Product Change Notice

Introduction of replacement die for below part numbers.

Figure 1

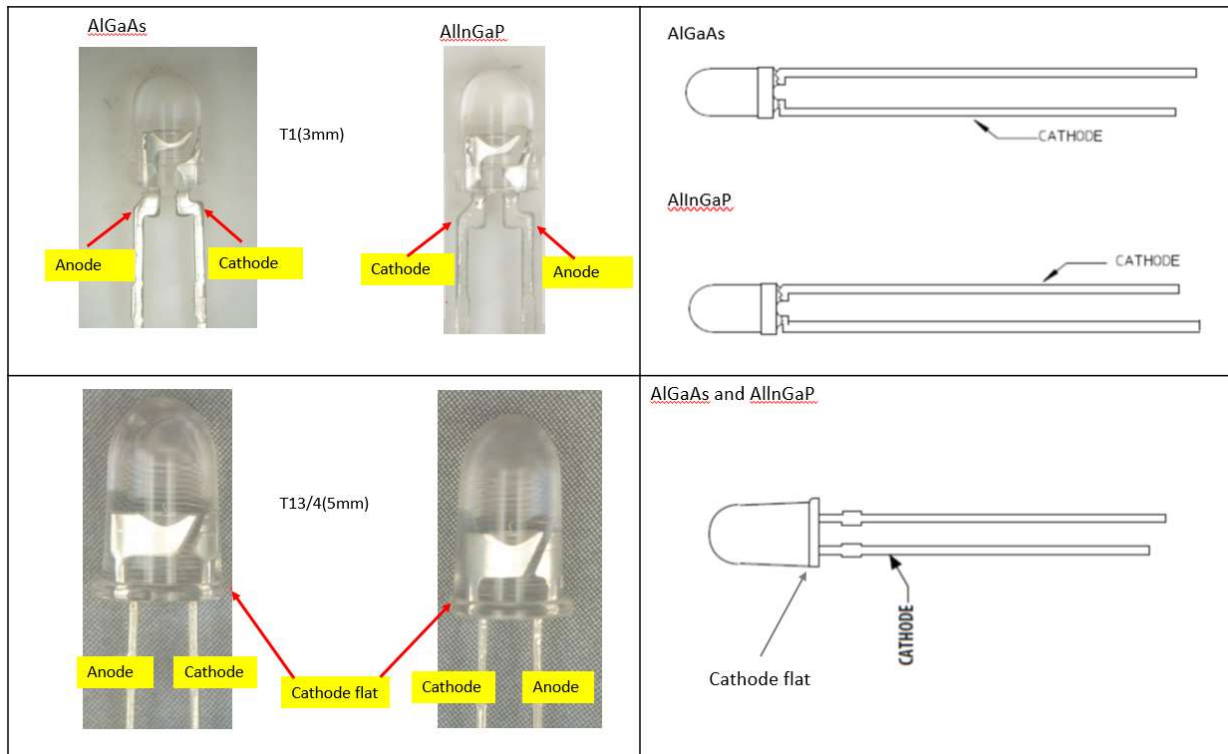
Group 2 (AlGaAs LED Lamps) will have a change in form as shown in Figure 1.

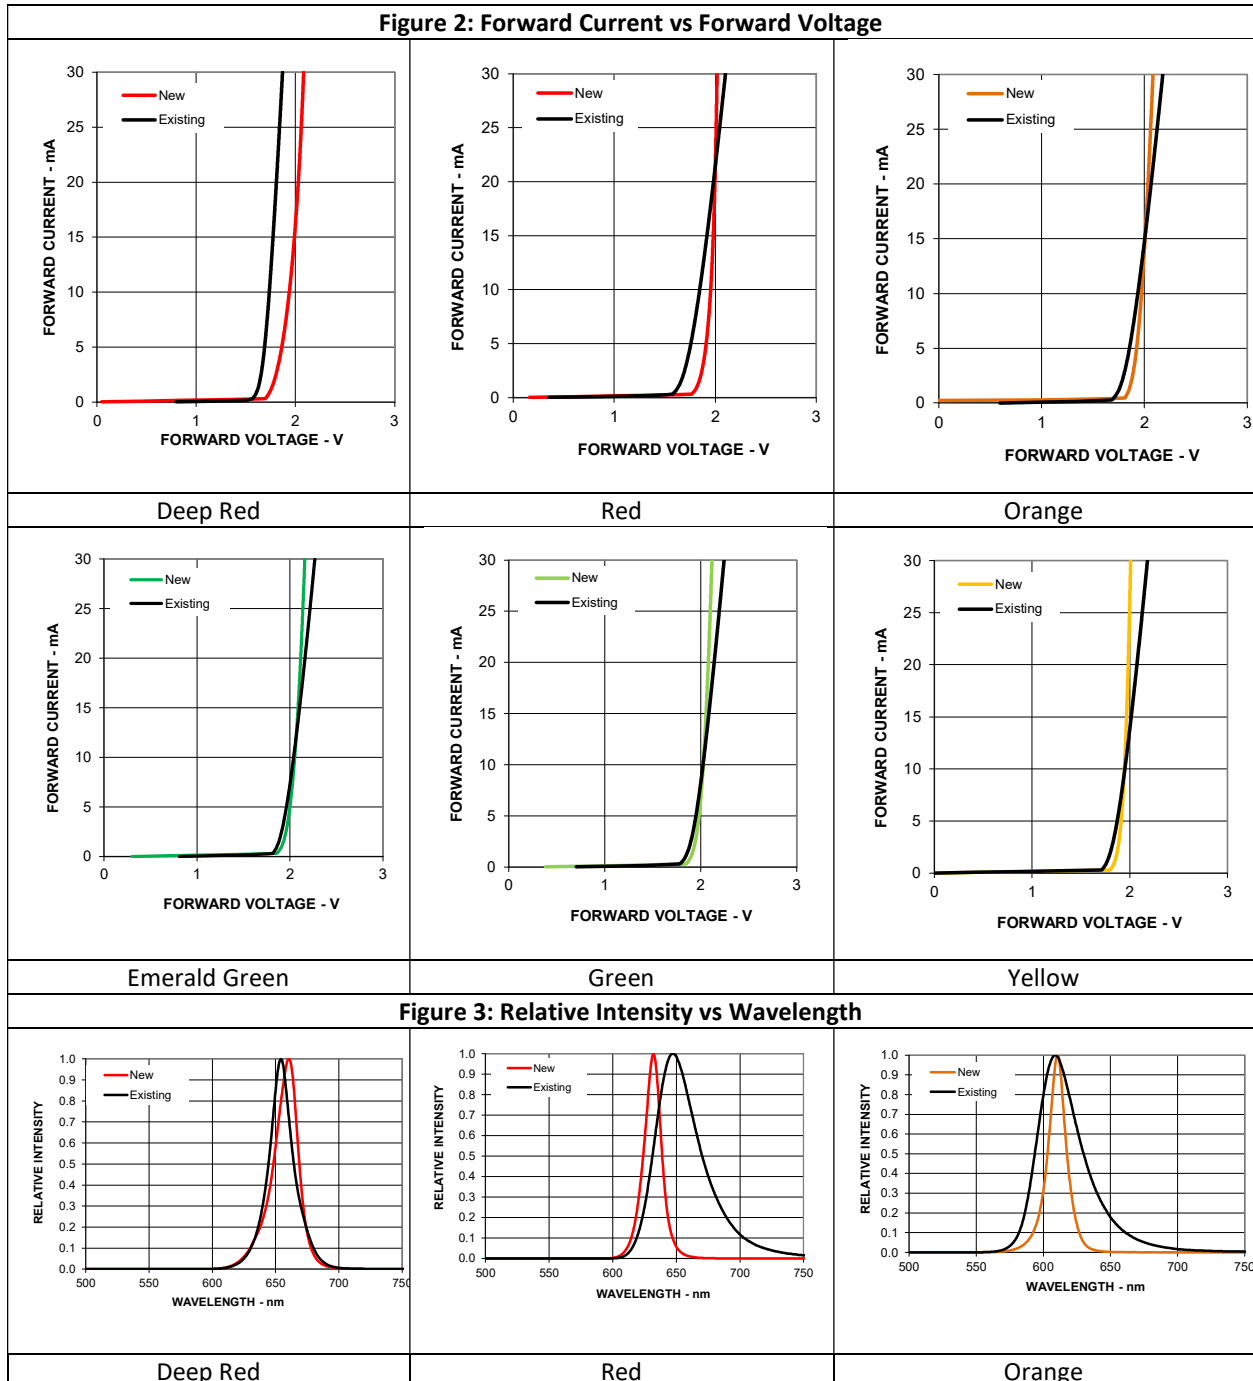
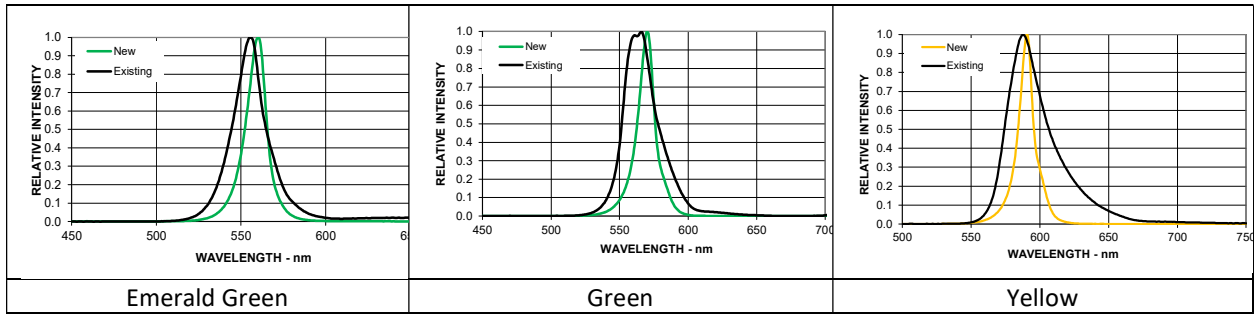
Following are the changes in product characteristic for both Group 1 and 2 of the LEDs.

1. Forward Current vs Forward Voltage.
2. Relative Intensity vs Wavelength
3. Relative Intensity vs Forward Current
4. Luminous Intensity : Some part numbers will experience higher typical intensity (refer to individual datasheet for details)
